From: Tony Sprckett, Spring Ridge Co-op Housing Assn.
Sent: November 15, 2024 1:11 PM
To: Legislative Services email
Subject: CONCERNS: RE Zoning Reg Bylaw, Amendment (No. 1347), No. 24-071
Attachments: 1276GladstoneAvePublicFeedback.pdf

Re: rezoning and development proposal for 1276 Gladstone Avenue

Folder #: CLC00414

Introduction

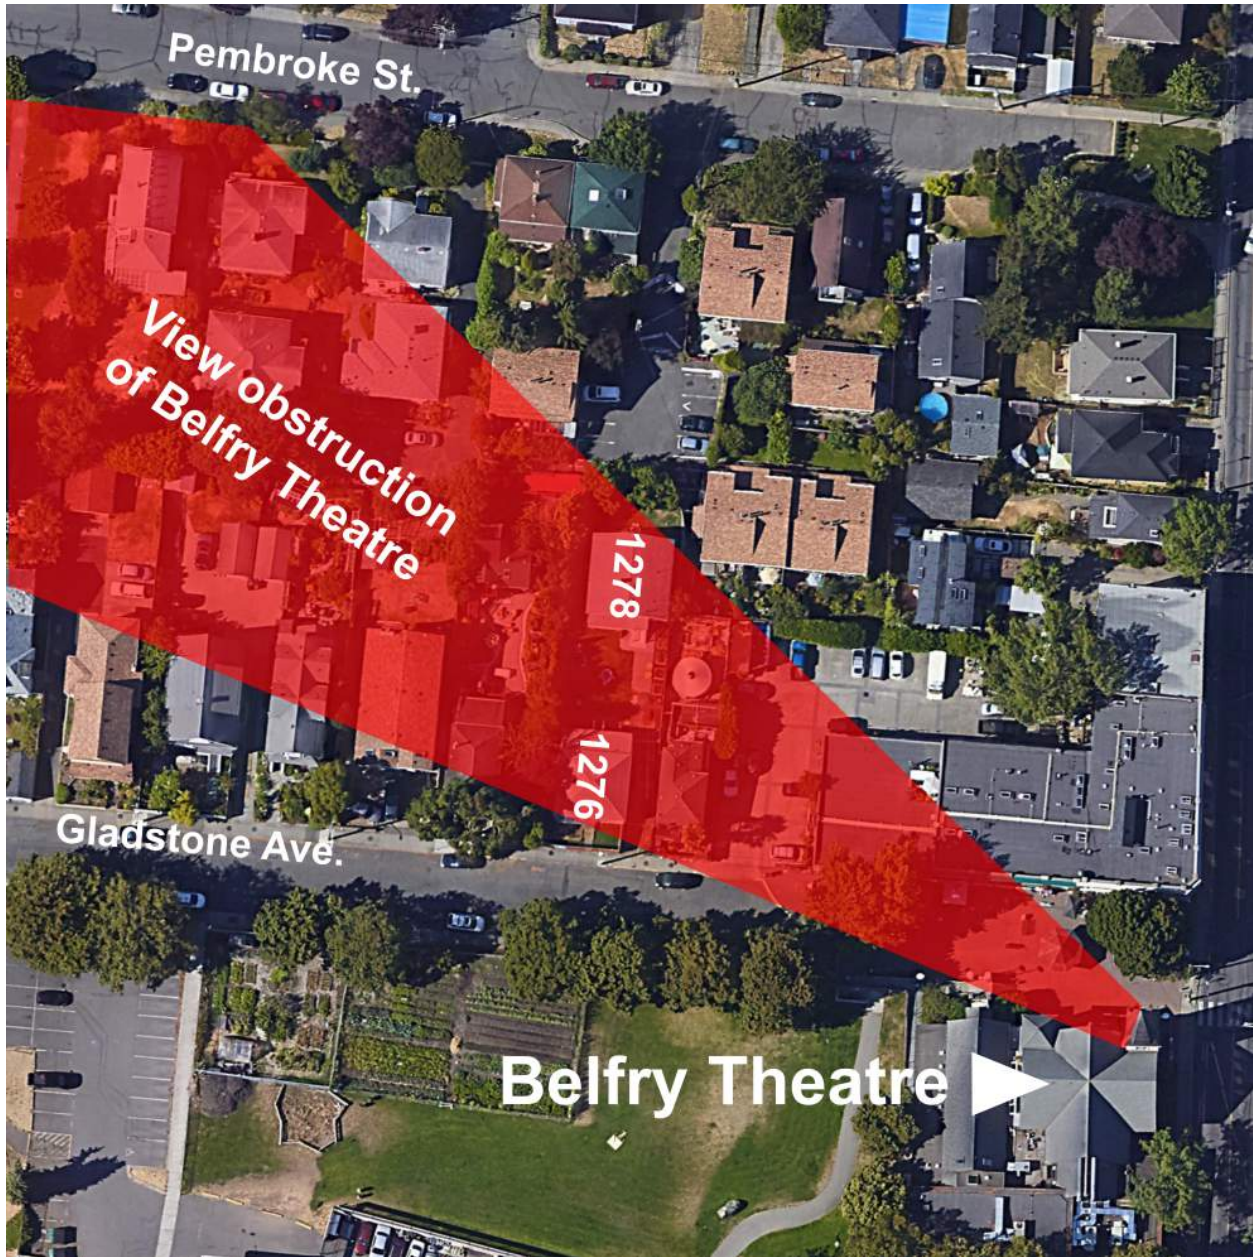
What is presented, next, is a height-adjusted mockup that uses the proposal's own images to show something closer to accuracy for what the development would look like for the properties to the northwest, north, and east. Note that the roofline caused by the vertical roof extensions, required for doorways to the roof, creates what is in effect, in terms of shading and sightlines, an additional storey.

Note that the image above also shows that 1276 Gladstone property is toward the top of a rise. Our co-op housing unit (which sits directly to the east, or left, in the above image) has a backyard that sits roughly 2-2.5m (6-8') below average grade on the 1276 Gladstone lot. The units to our east are also built into a depression, such that the last unit in our fourplex is another 2m down.

As proud as we are of our small gardens and food growing spaces, we already often joke that it's like trying to farm at the bottom of a well. A four storey building would look to us more like a 5 storey building, and the addition of the vertical extensions of the roof make this build visually closer to 6 storeys.

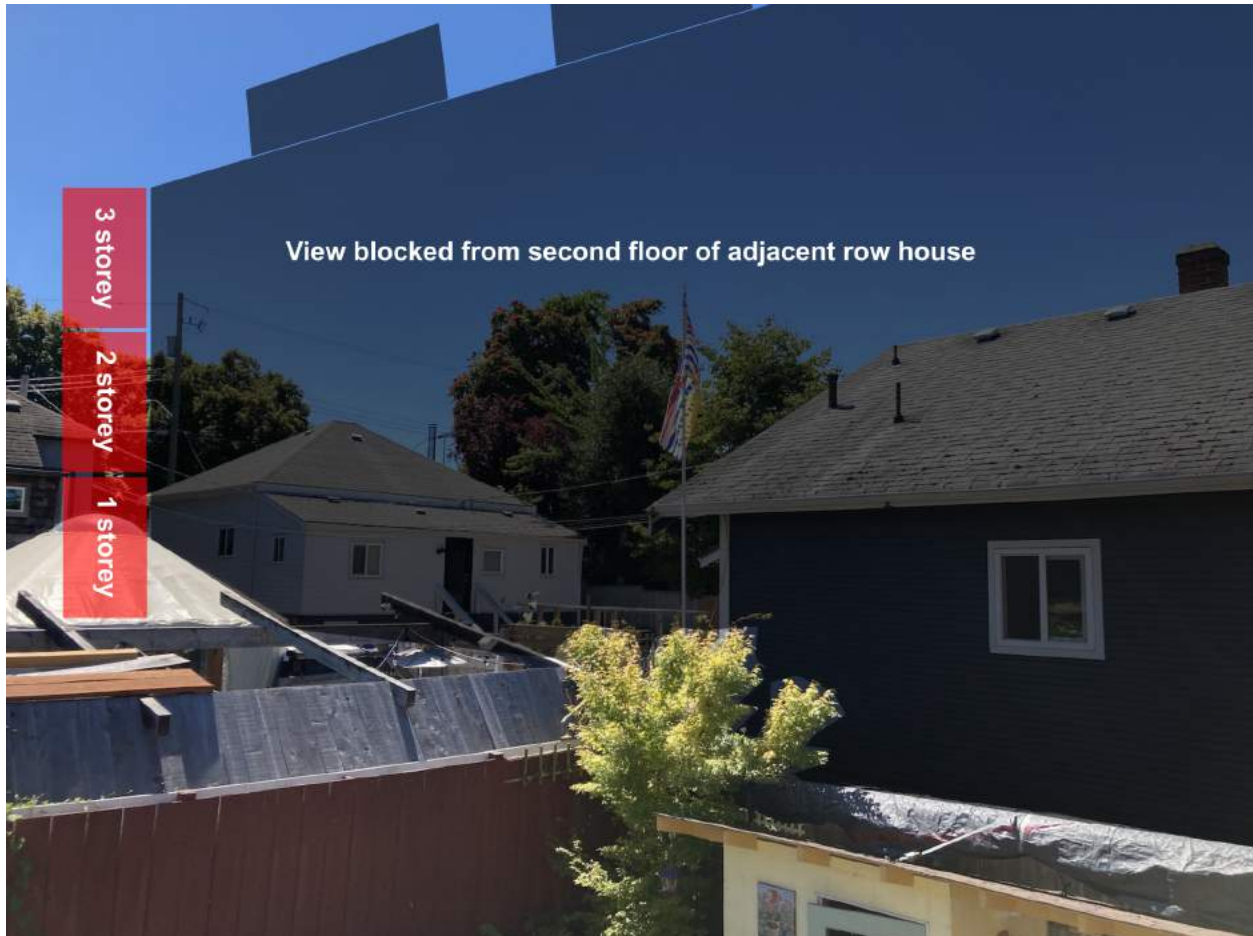
Our fourplex's western wall, for example, sits 2m from the lot line. The developers' plan, which proposes 1m side-lot setbacks narrows this already small gap to the adjacent building even further. Furthermore, these setbacks will be decreased toward the rear of the property line.

We already feel the lighting loss and presence of the current building, and an additional height, like that of the proposed development, will loom over us and our neighbour's properties.

Note, again, that the natural slope of the land is such that toward the rear of the property, the height increases significantly, relative to the surrounding properties, effectively blocking the view to the west entirely for many existing residents.

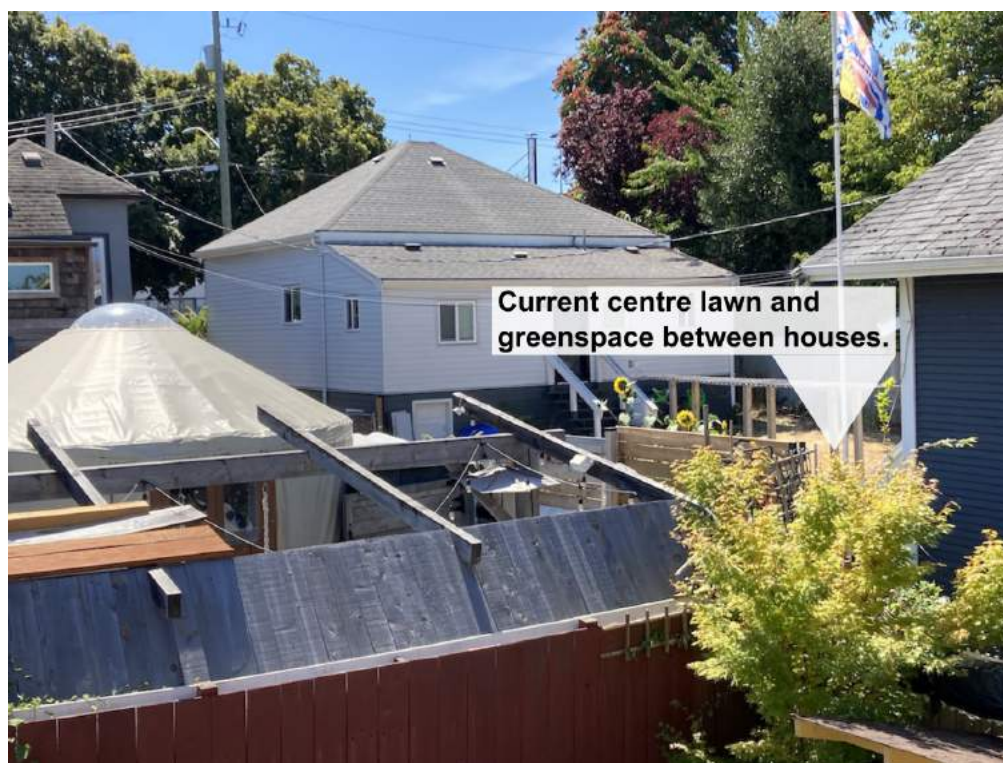
As the following overlay image shows, the developers’ design is disproportionate to the surrounding properties. Its setbacks and height dominate the lot and its surroundings.

Moreover, its use of “stamped concrete” paths as a perimeter and its side and rear walls of black, corrugated steel do little to humanize its design, which appears in contrast to the property’s current character of unique homes as overtly industrial, something more in keeping with storing objects than housing people.

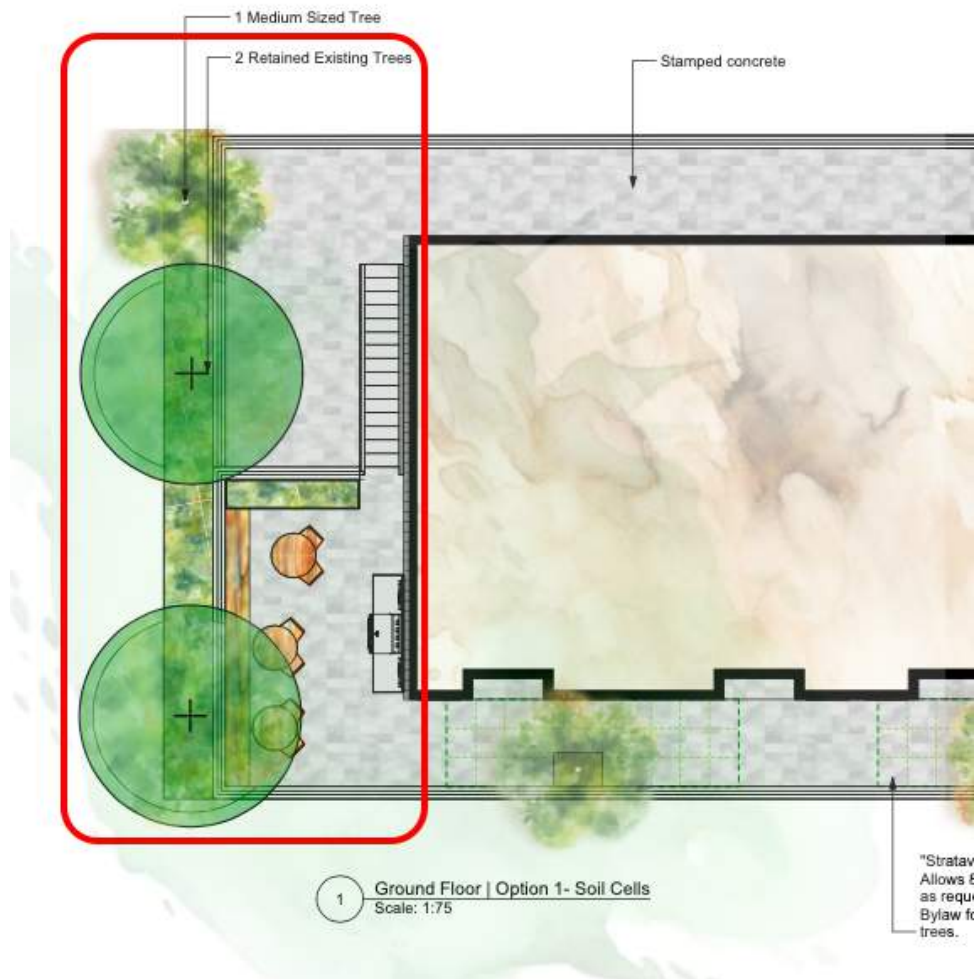
Page 31 of the design plan notes the inclusion of “4-Proposed Vine Maple trees,” and the term *proposed* should be emphasized, as the property to the west already has established tall trees, and so any new trees would not grow in the location suggested due to both shade and root competition.

Page 31 of the design plan also indicates the retention of existing trees, suggesting that these trees are part of the development property, as seen in the following image:

This aspect of the plan is very troubling as it suggests that the retained trees would remain, at the developer's behest, as part of the overall design consideration. In other words, the developers are leveraging this aspect of the current space to create a narrative of green-space concern. However, this is a misrepresentation on two fronts.

First, the trees in the design are not on the 1276 Gladstone property: they are on the other side of the 1276 Gladstone property line (and fence) and are maintained and owned by Spring Ridge Coop (see image below). Second, the notion of "retaining" these trees fails to account for their gradual demise due to loss of light and the root disturbances caused by digging a foundation only 1m back from the lot line, as proposed.

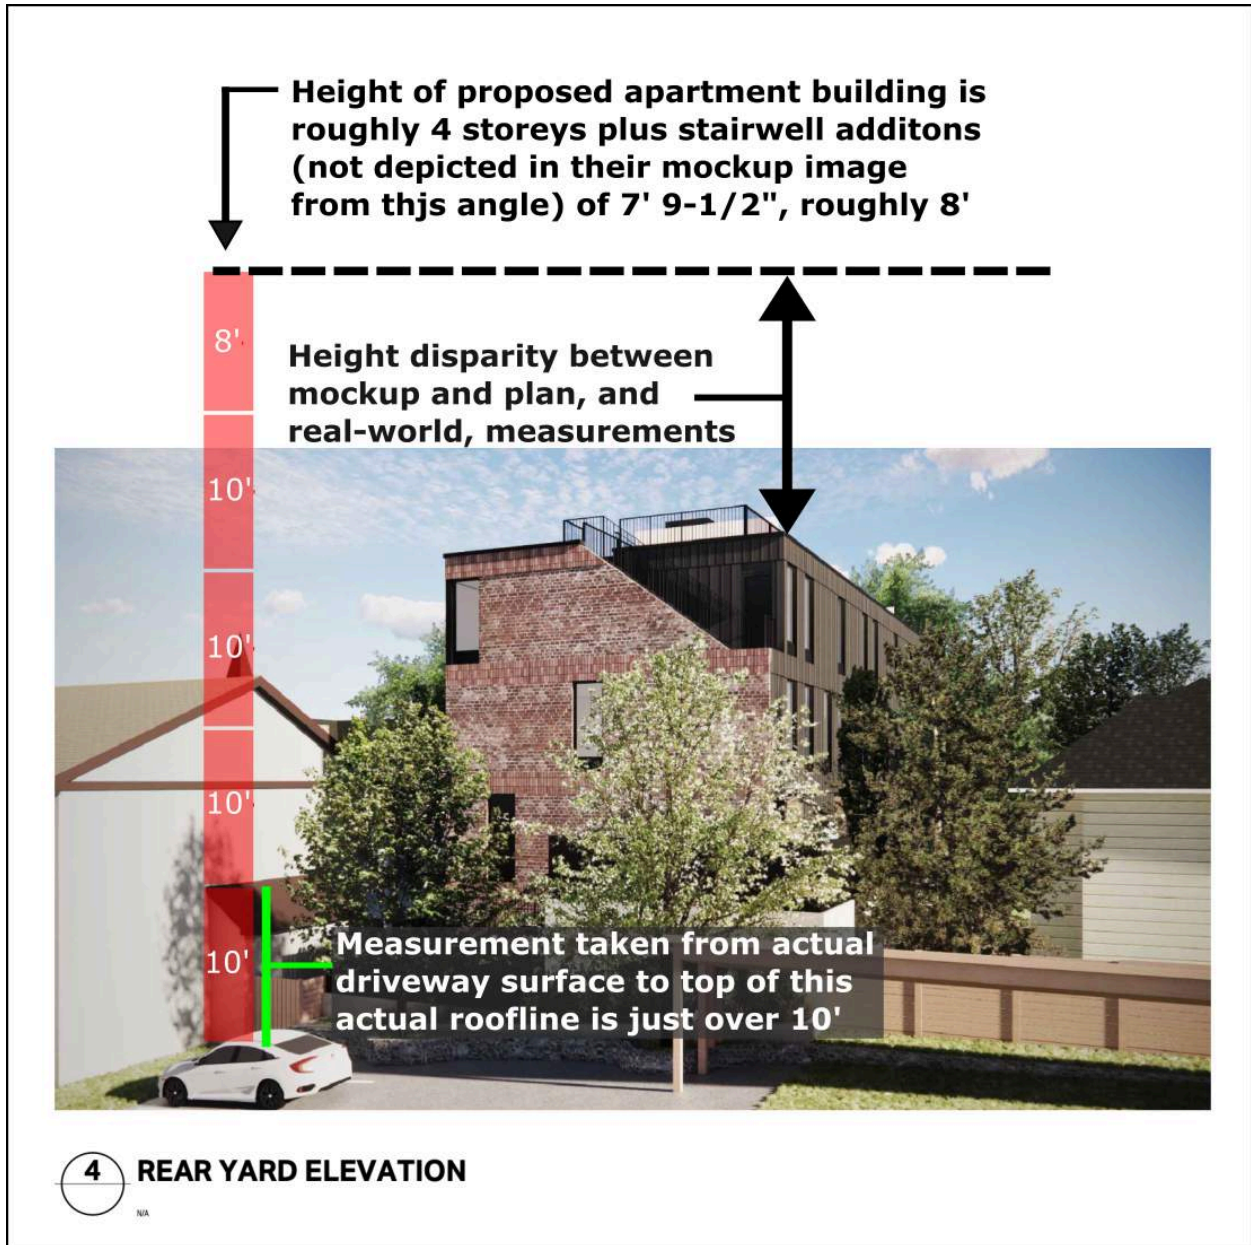
The first appeal presents a height-adjusted mockup that uses the proposal's own images to show something closer to accuracy for what the development would look like for the properties to the northwest, north, and east.

Note that the image above also shows that 1276 Gladstone property is toward the top of a rise. Our co-op housing unit (which sits directly to the east, or left, in the above image) has a backyard that sits roughly 2-2.5m (6-8') below average grade on the 1276 Gladstone lot.

Turning to the revised mockup of the same view, the height distortion in the mockup reduces drastically the relative peak of the roof height on the proposed development.

2 FRONT ELEVATION

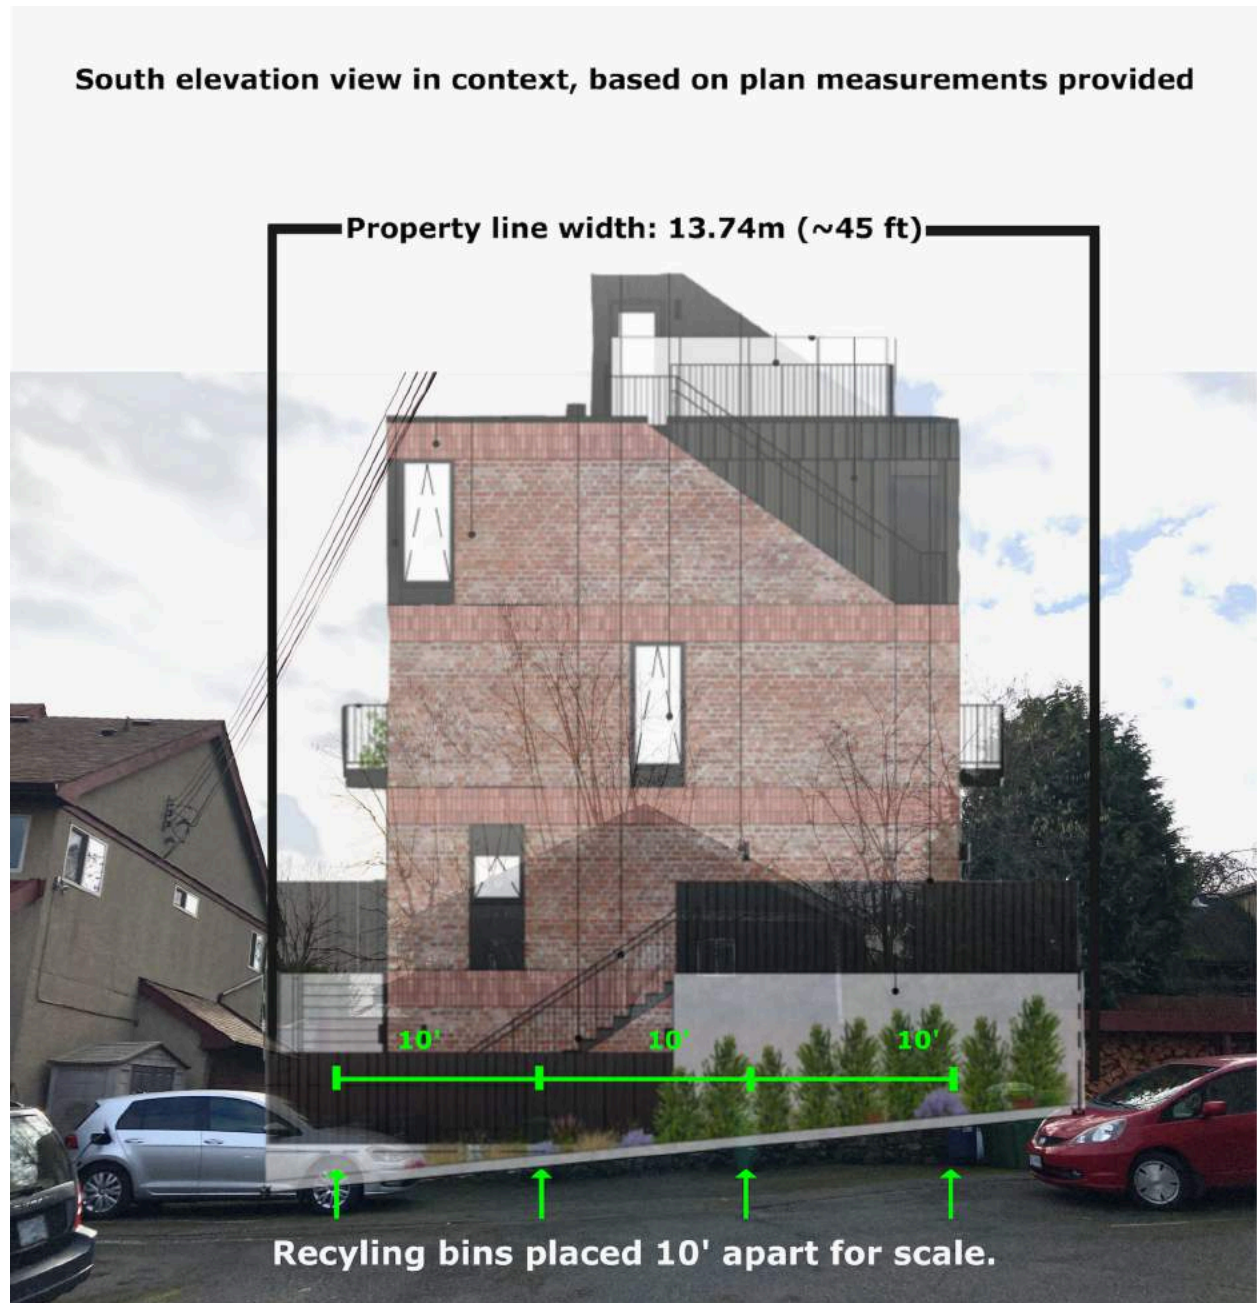
The development proposal's only face-on, north-side mockup image, "South Elevation" (2023-12-13 - Plans_Revisions.pdf, p, 16), is presented without any surrounding buildings, making it impossible to visualize its scale relative to the surrounding properties:

The “Front Elevation,” or south-side mockup (p. 18), however, does depict the building in context with the surrounding buildings. Showing this view in context makes sense from a persuasion perspective; after all, the front face of the building, at 3 storeys, looks relatively smaller than the south elevation image:

Adjusting for the in-place scale of the northern property line, and using the measurements in the developers' plan, this is a more accurately scaled view of the South Elevation mockup:

Note that the opacity of the south elevation image is adjusted to show the existing house (1278 Gladstone), the roofline of which appears relatively short compared to the house to the east because the 1278 Gladstone sits closer to Gladstone than the proposed building, which pushes to within 1m of the northern property line.

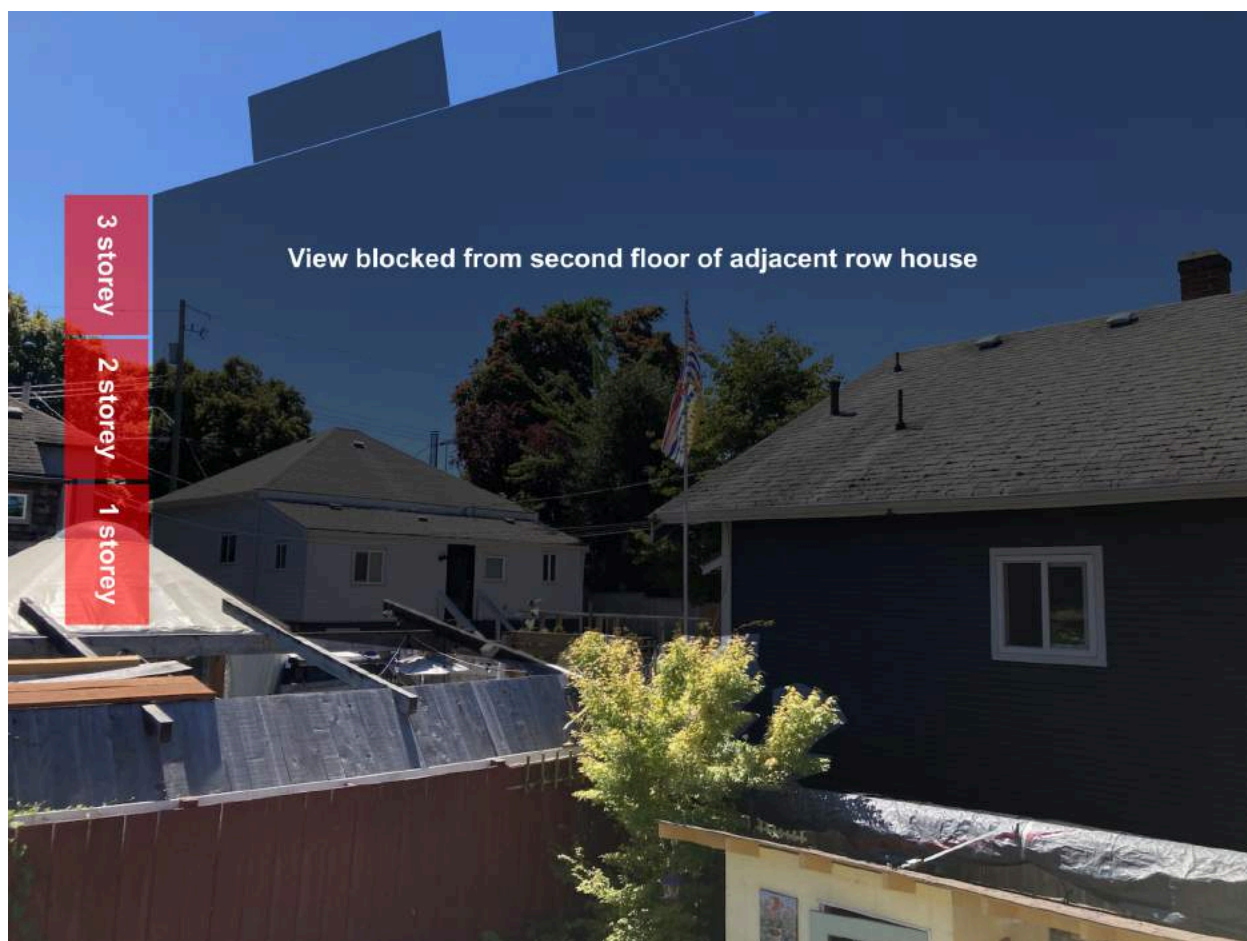
This change is hardly significant, and particularly ineffectual for the buildings to the east and west, those most affected by the shade and privacy impacts of the build. In other words, none of their design changes address the “shade impact” to the east and west.

Moreover, the area directly to the north of the 1276 Gladstone property is a parking lot and therefore has a relatively reduced concern for shade, with the exception of the productive hazelnut trees to the north of the adjacent property (discussed below).
